**Lee Nuclear Station Units 1 and 2  
Description, Scope of Changes, and FSAR Impacts due to Plant Relocation and  
Additional Design Enhancements**

**Description and Rationale for Lee Nuclear Station Units 1 and 2 Relocation and  
Additional Design Enhancements**

**Figure 1.1-202**

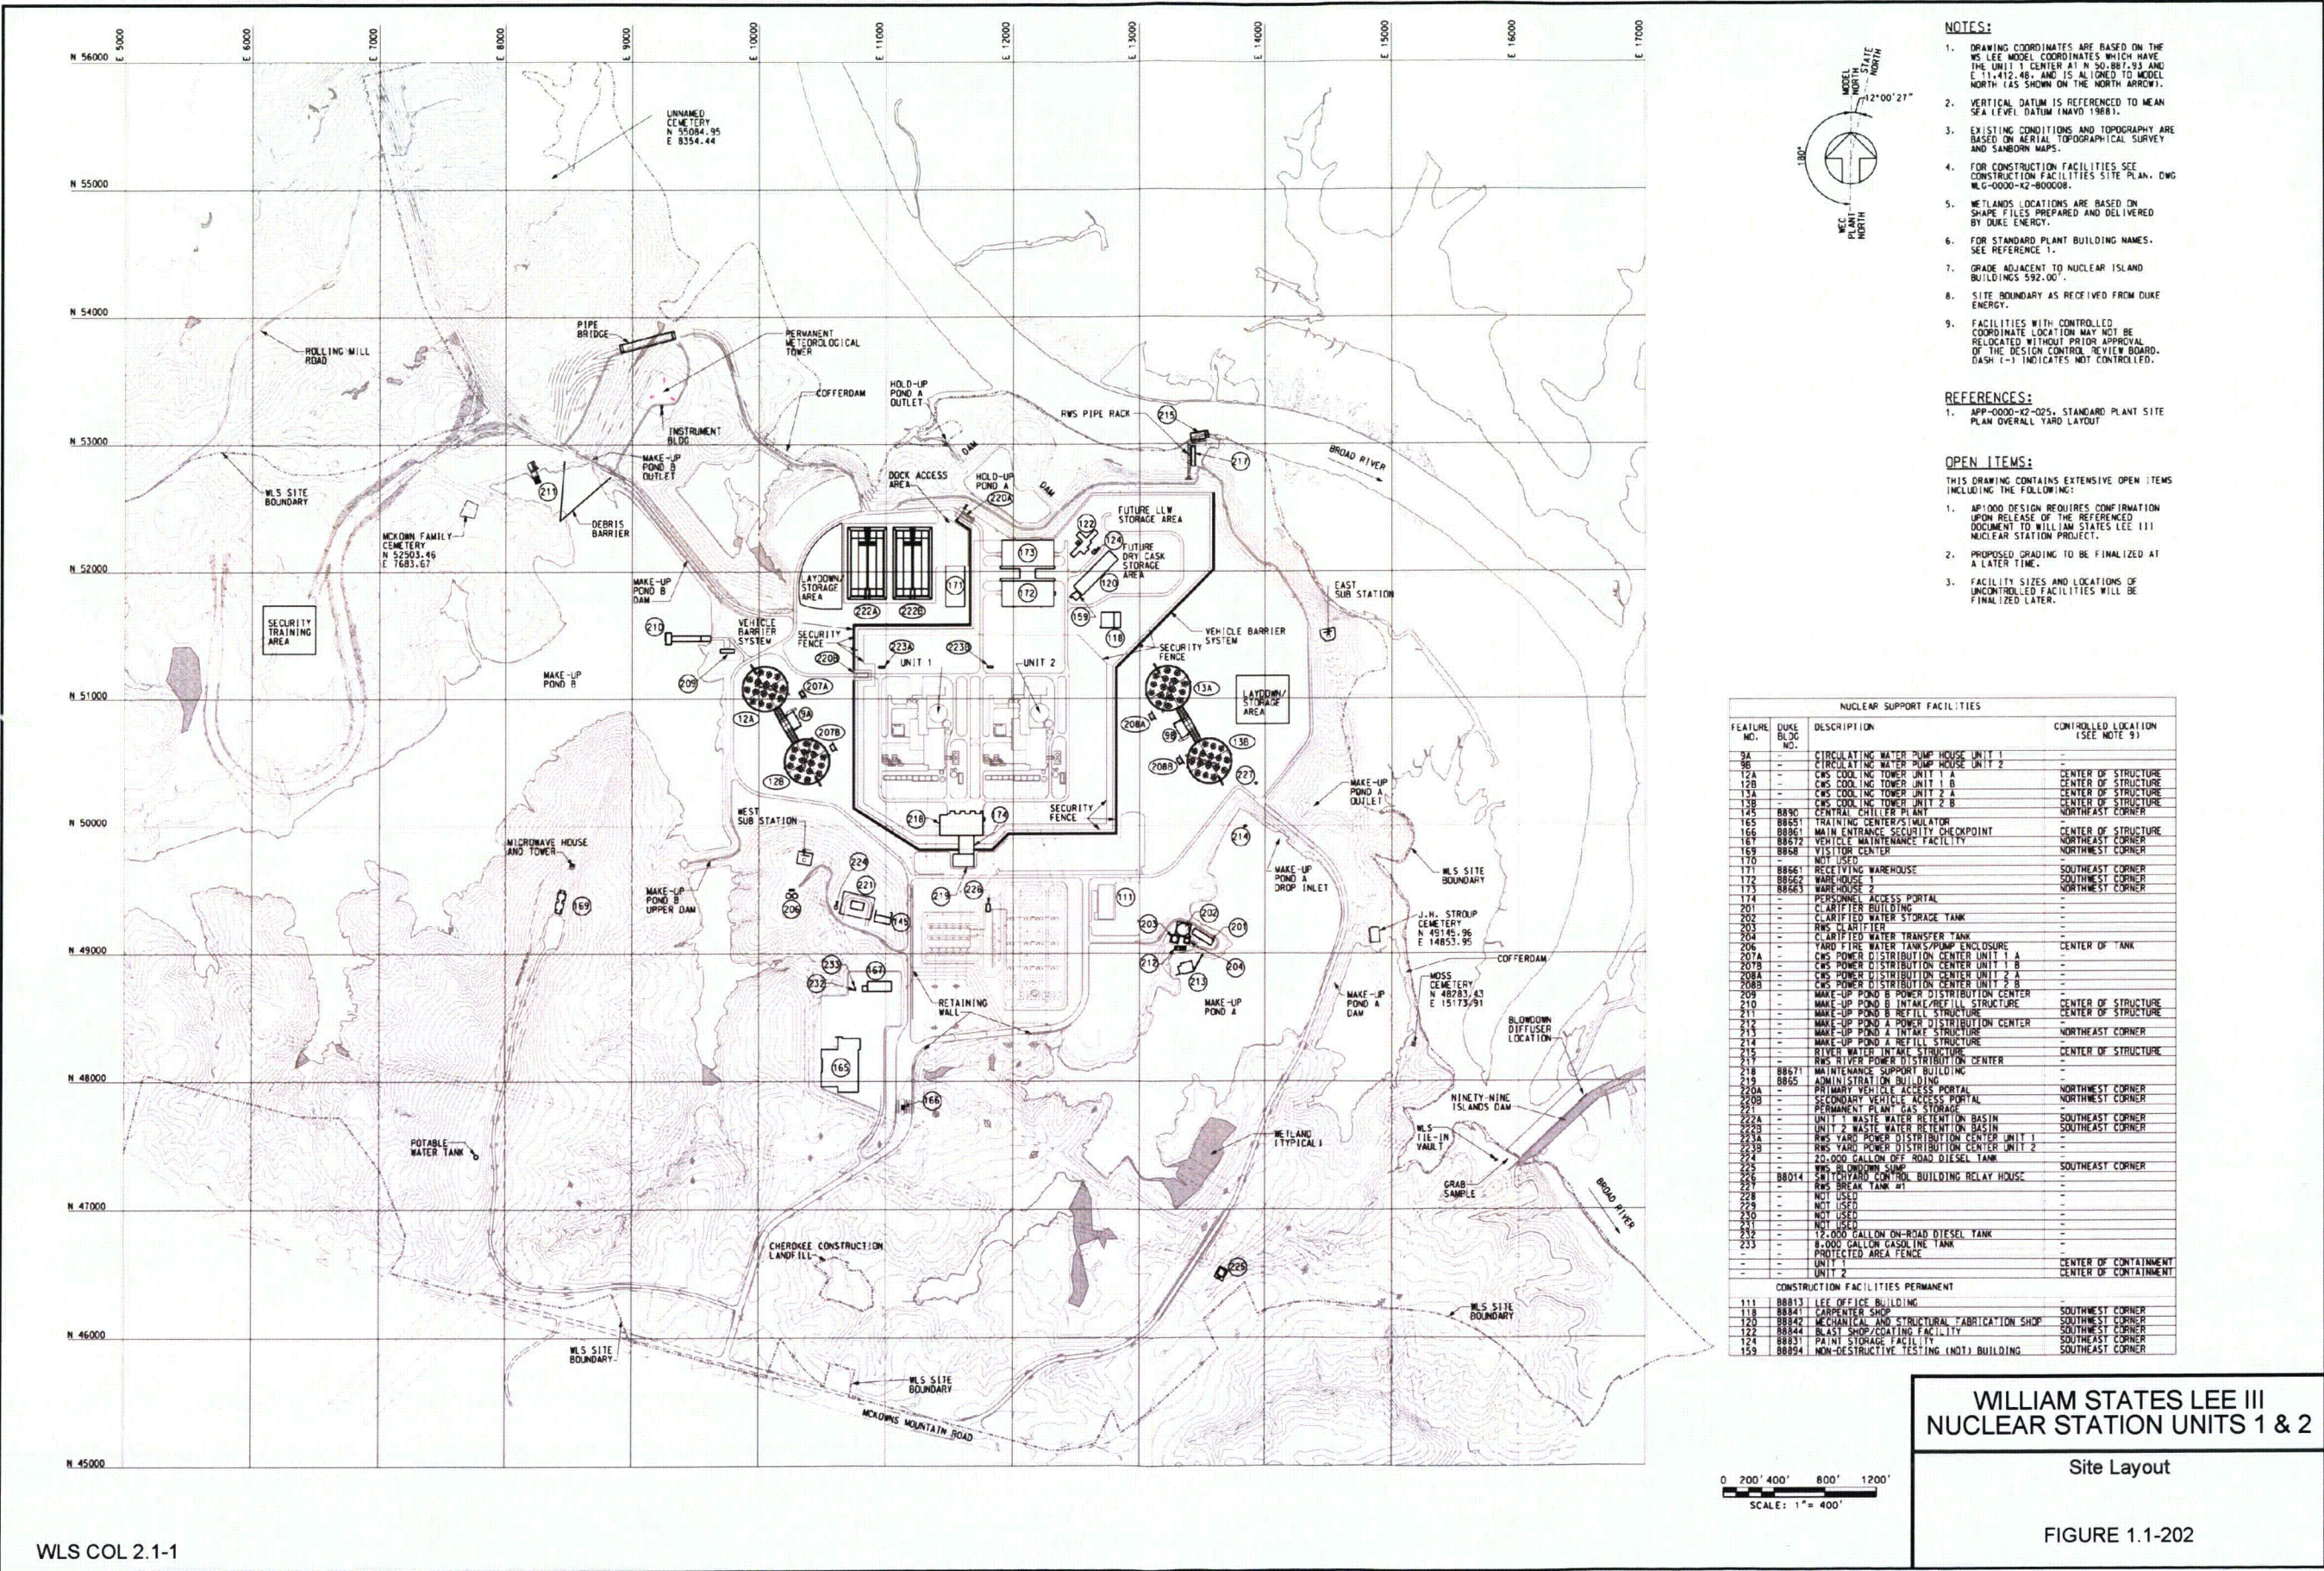
The site plan for Lee Nuclear Station is shown on Figure 1.1-202. Principal structures and facilities, parking areas, roads, and transmission lines are illustrated. Orientation of the two AP1000 units is such that "plant north" faces 168 degrees from true north. Unless otherwise noted, directions in this subsection are based on true north. Similarly, design plant grade for the DCD is defined as 100 feet, whereas design plant grade for the Lee Nuclear Station Units 1 and 2 is ~~590-593~~ feet; therefore, DCD elevations are to be increased by ~~490-493~~ feet to be actual site elevations.

2. COLA Part 2, FSAR Chapter 1, Figure 1.1-202 is revised as follows:

Figure 2.1-209

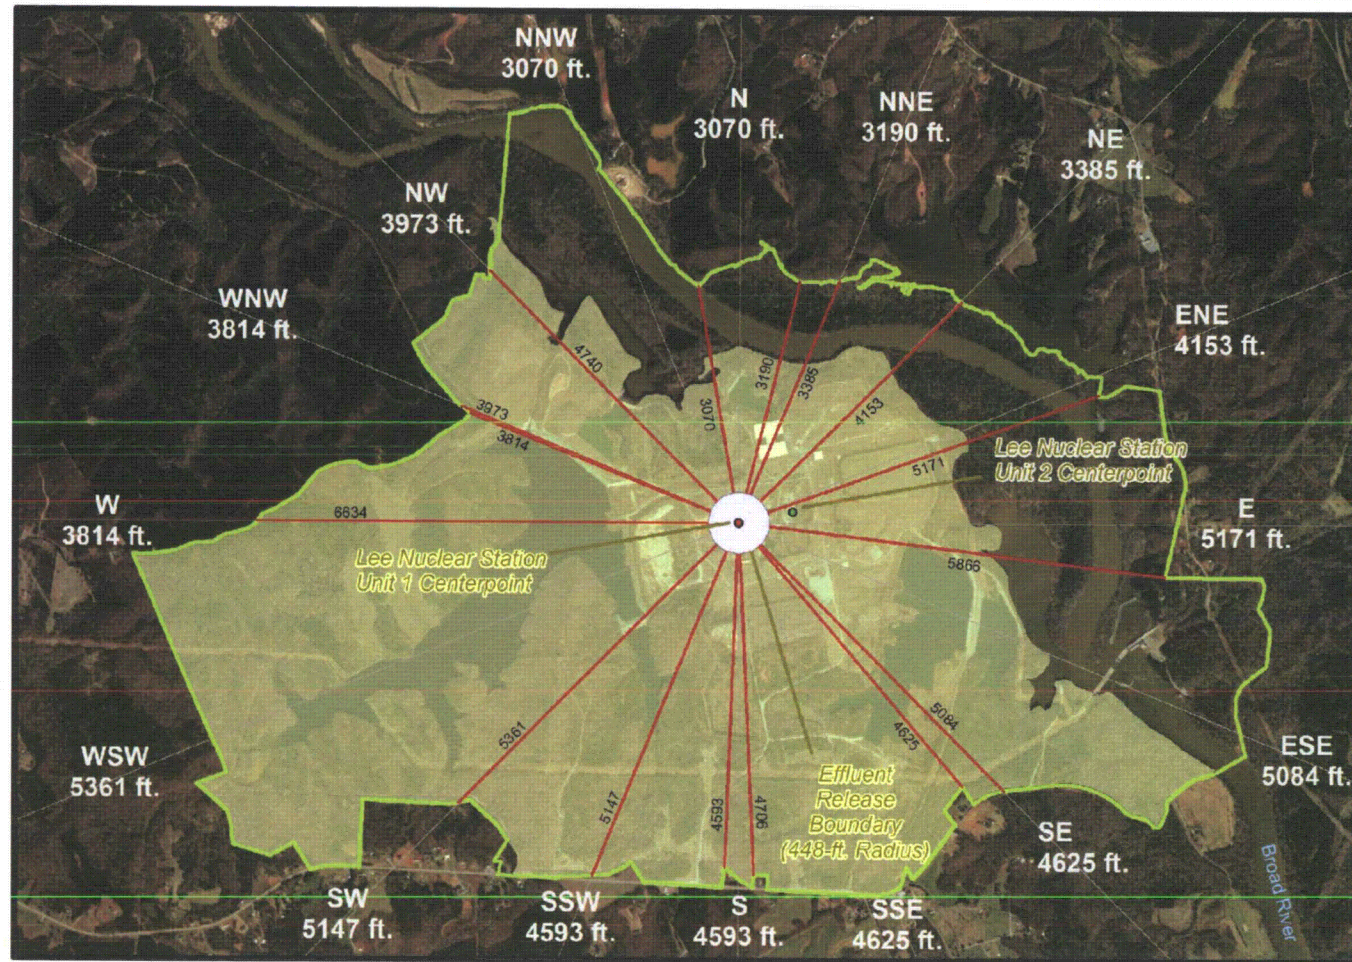
5. COLA Part 2, FSAR Chapter 2, Figure 2.1-209 is deleted to provide EAB distances for each unit, presented as Figure 2.1-209A and Figure 2.1-209B as follows:

FIGURE 2.1-209A

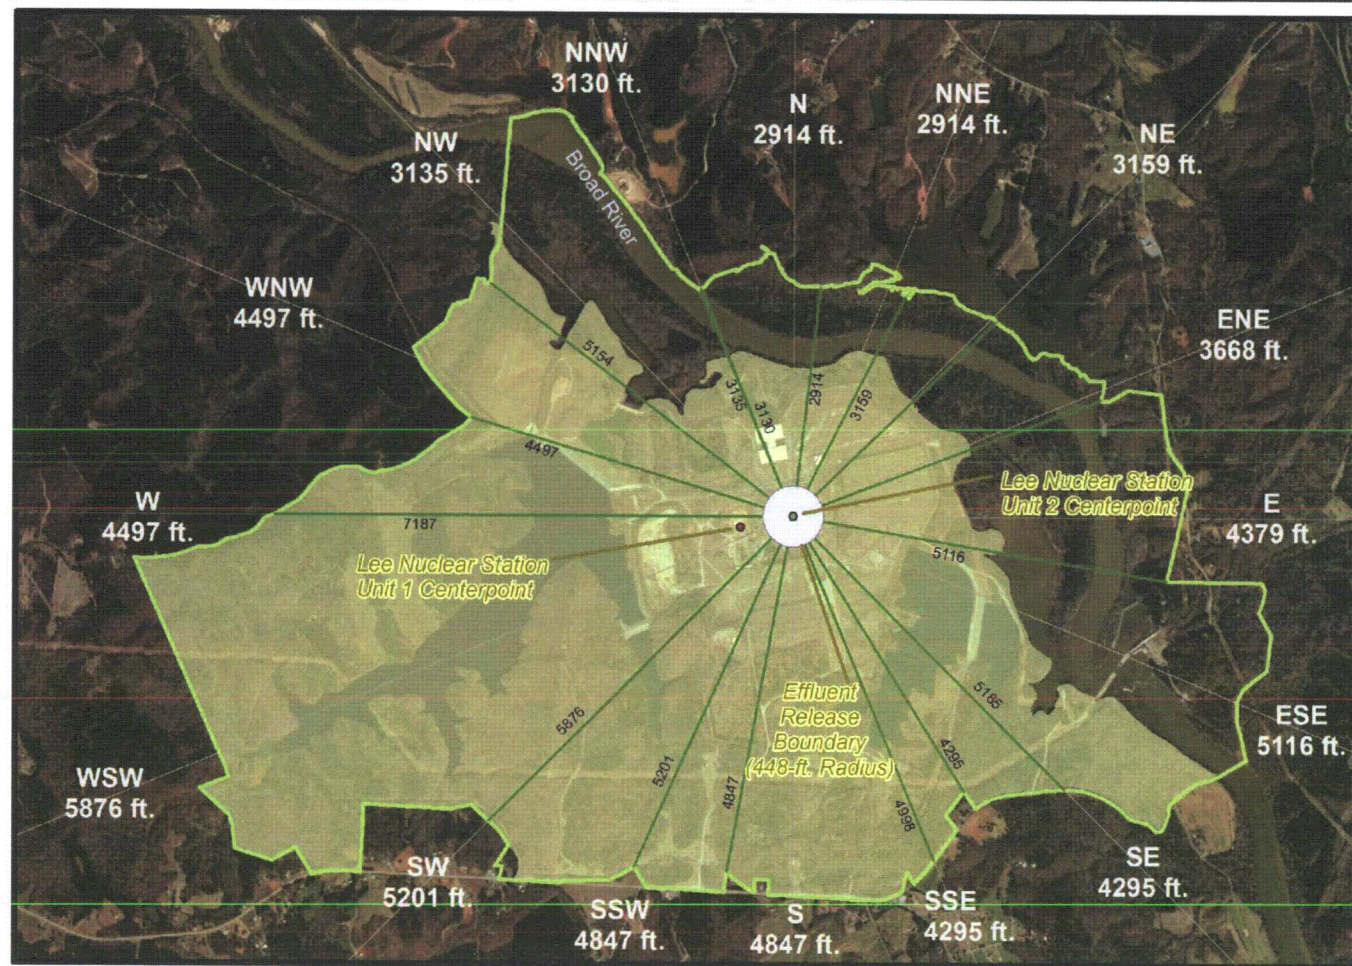
The Exclusion Area Boundary for the Lee site has been modified. The EAB has expanded to allow the site to satisfy the AP1000 DCD 0.5 mile minimum distance parameter to the EAB (DCD Table 2.1, Sheet 3 of 4) from each reactor center point. The revised EAB boundary was extended across the Broad River to the northern direction and slightly modified portions of the southern and western boundaries, as illustrated in Figures 2.1-209A and 2.1-209B.

6. COLA Part 2, FSAR Chapter 2, Figure 2.1-209A is added as follows:

FIGURE 2.4.1-201

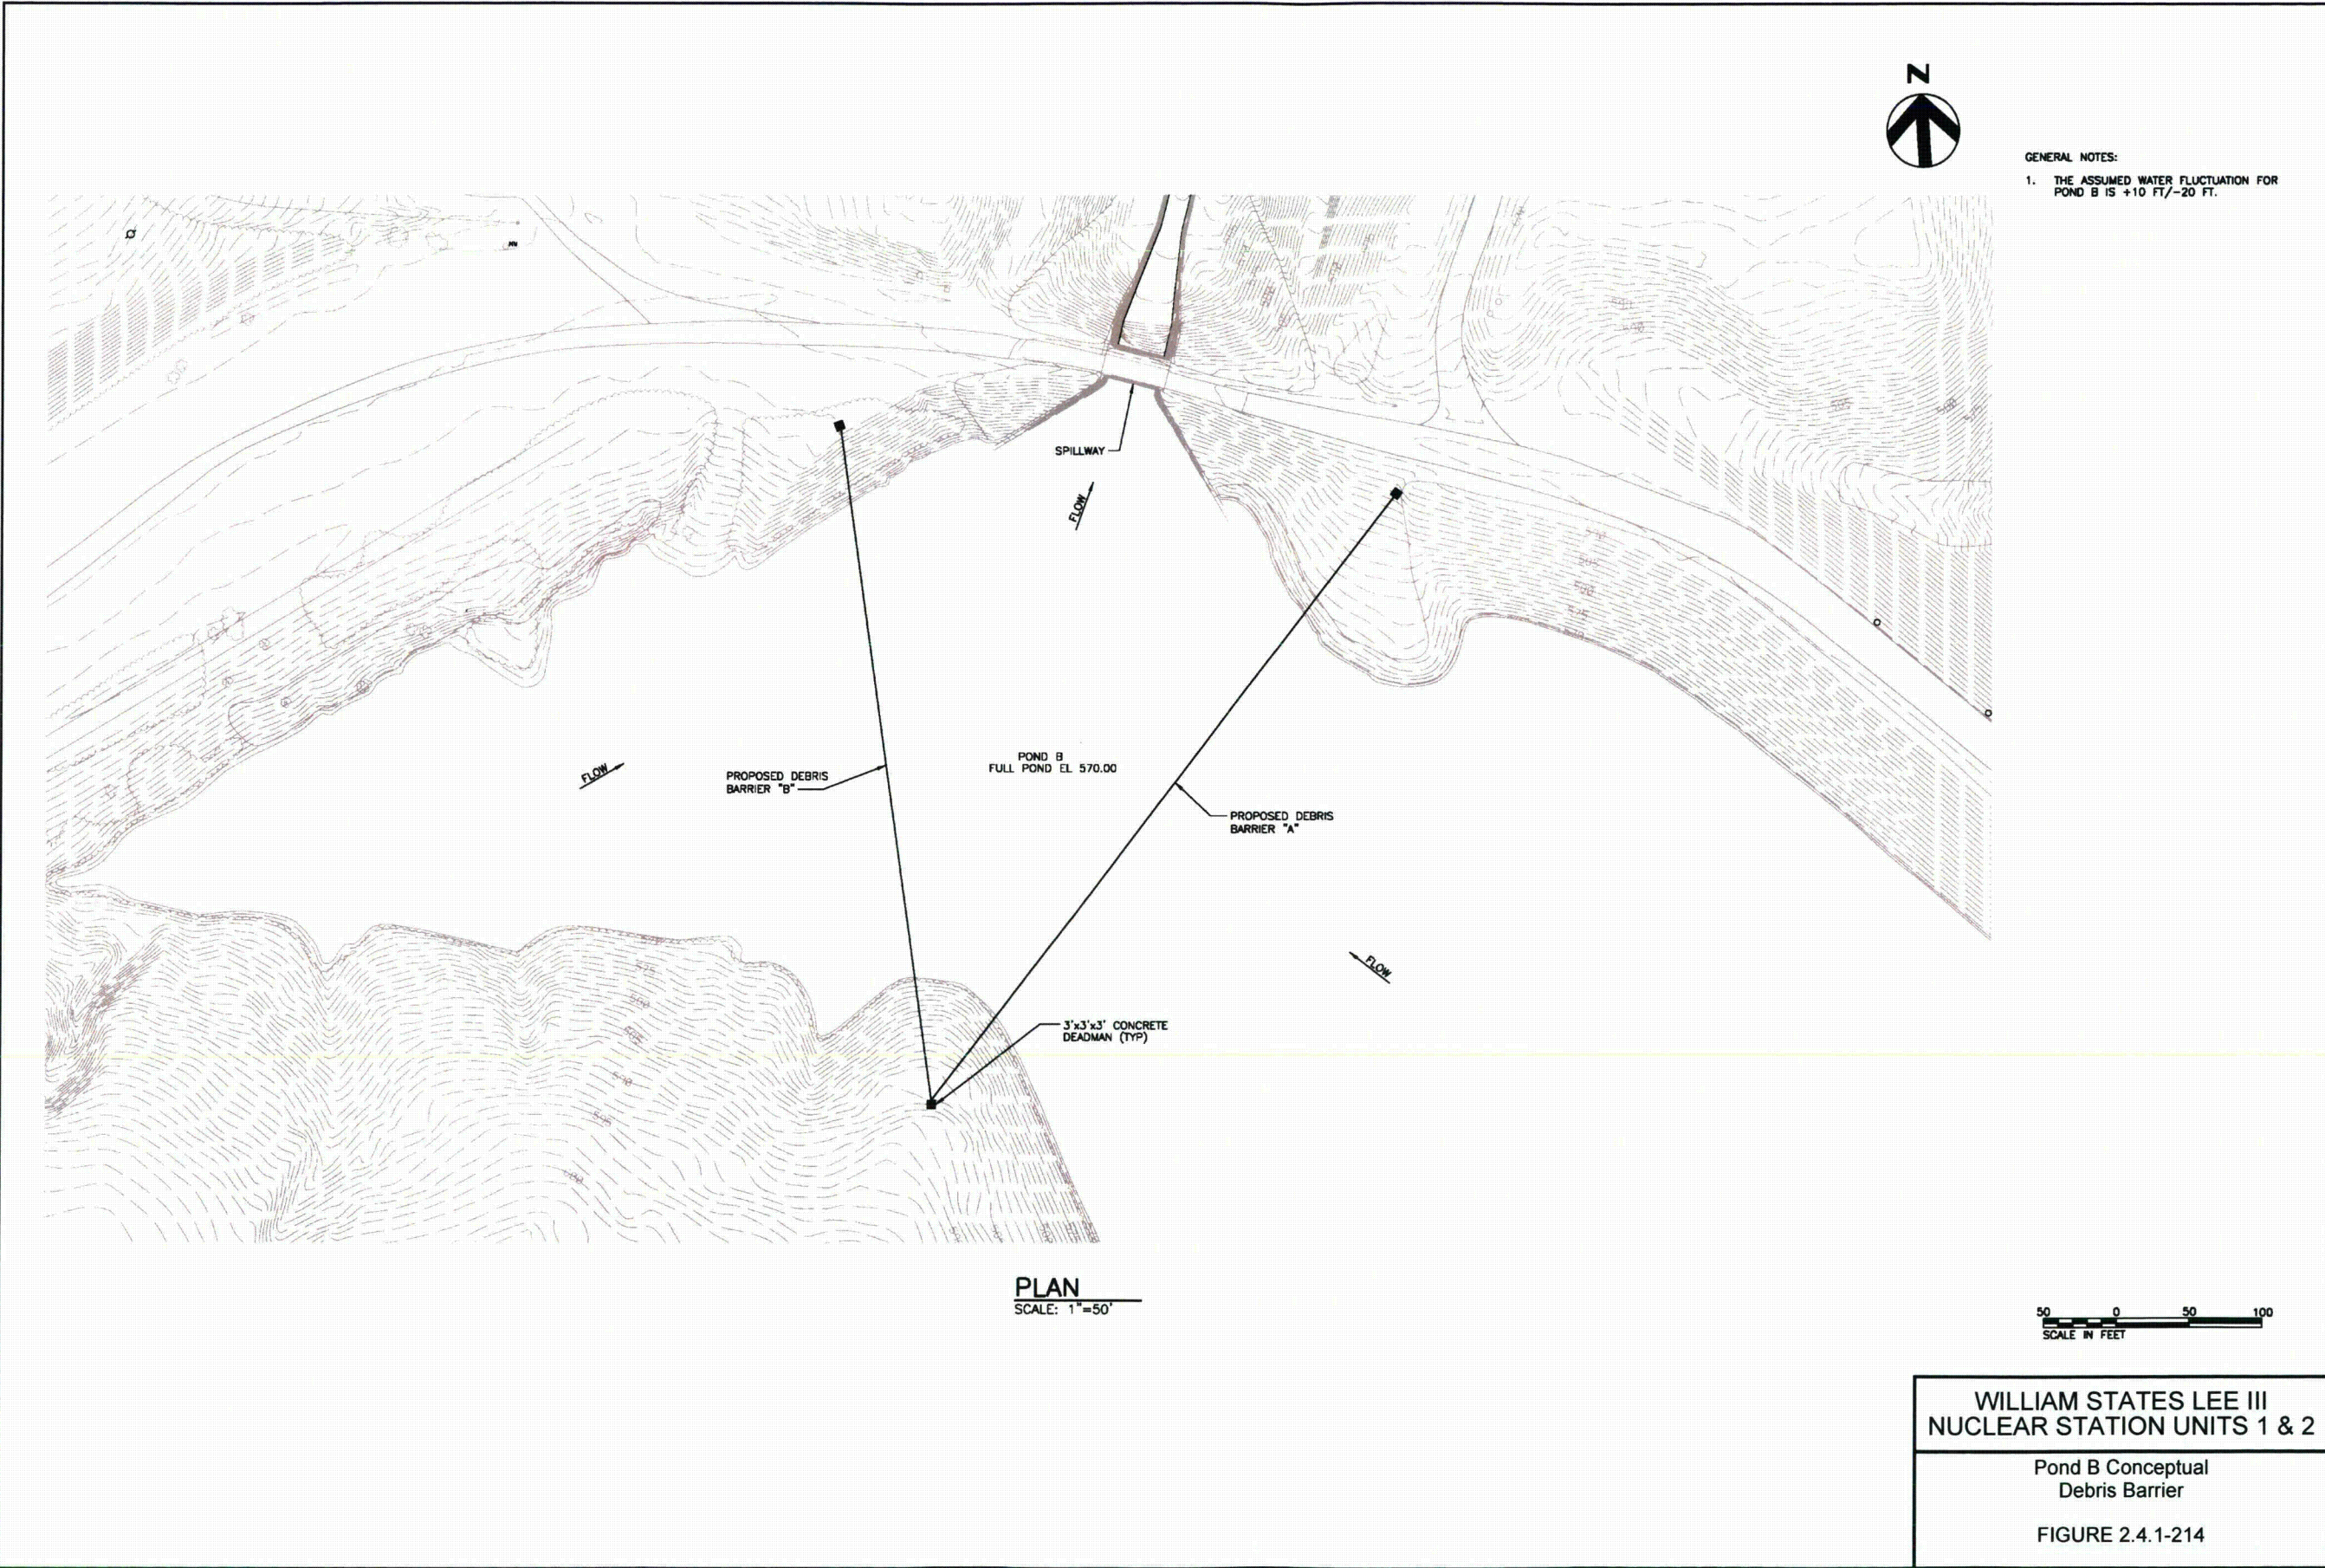
42. COLA Part 2, FSAR Chapter 2, Figure 2.4.1-201 is revised as follows:
